Appln. No. 10/654,956  
Amdt. dated November 30, 2006  
Reply to Office action of October 6, 2006

**Amendments to the drawings:**

**REMARKS / ARGUMENTS**

FIGURE 15b

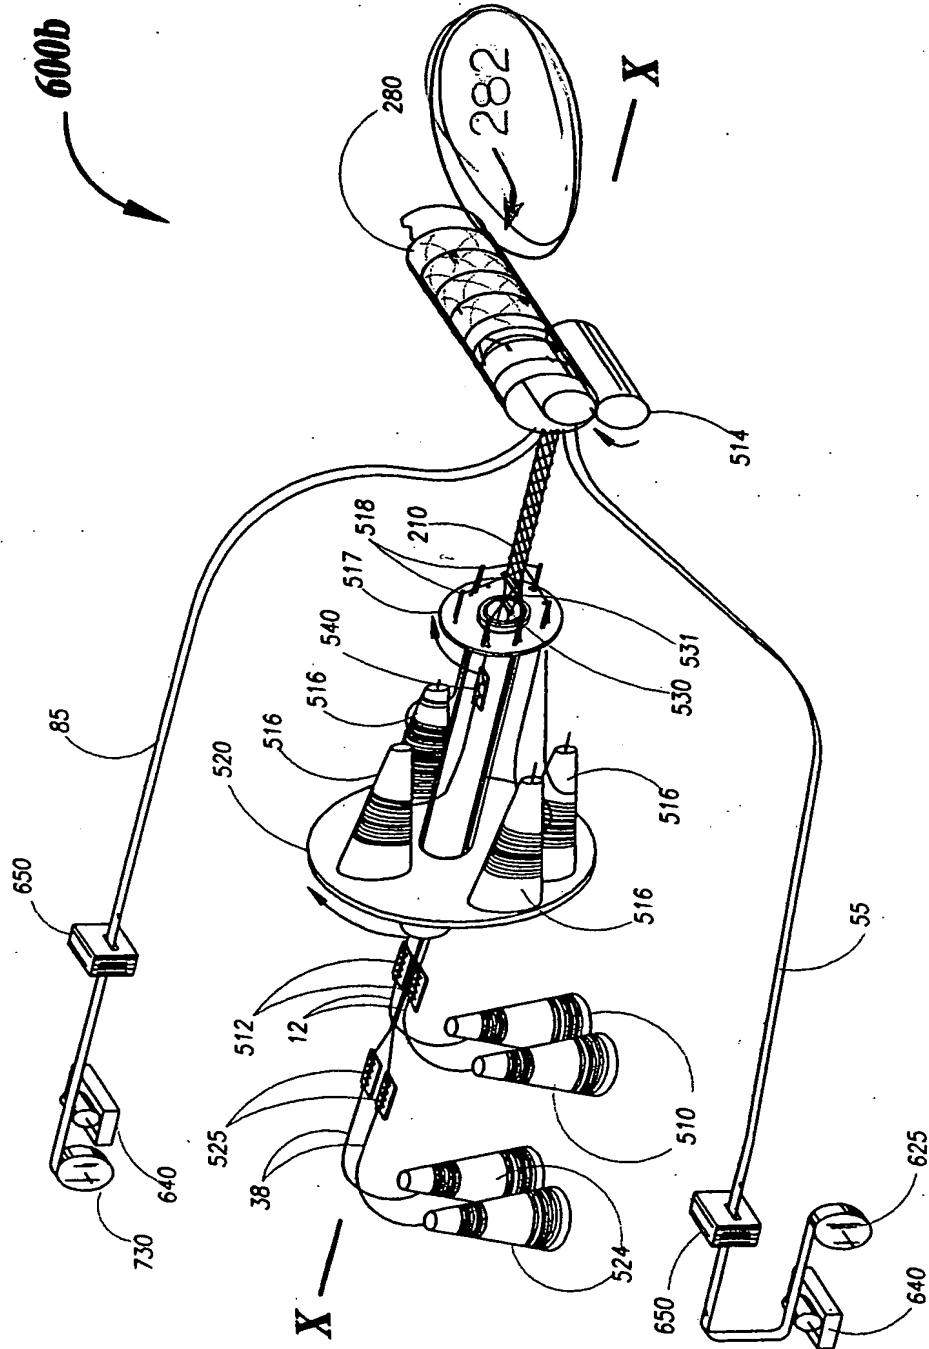
The attached sheets of drawings includes changes to Fig. 15b, 15d, 16 and 16a. These sheets, which includes Fig. 15b, 15d, 16 and 16a, replace the original sheets including Fig. 15b, 15d, 16 and 16a.

Inasmuch as the discussion involved the word "conduit" and how it was referred to in the specification, the applicant also desires to amend the application to include reference numbers specifically identifying the conduit as discussed in the specification and as shown in the drawings, all as filed. Accordingly, we enclose revised paragraphs 102, 104, 105, 106, 107, 109 and 110, to more clearly identify the laminate by reference to numeral 280, 280b, 380b and 300. We also enclose revised figure 15b in which the numeral 282 has been added to the conduit illustrated therein, figure 15d to which the numeral 382 has been added to the conduit illustrated therein, figure 16 to which the numeral 282b has been added to the conduit illustrated therein and figure 16a to which the numeral 382b has been added to the conduit illustrated therein. In each case this is assigning a numeral to the conduit as shown in the drawings and as described in the specification, all as originally filed. Thus, no new material is involved in these changes.
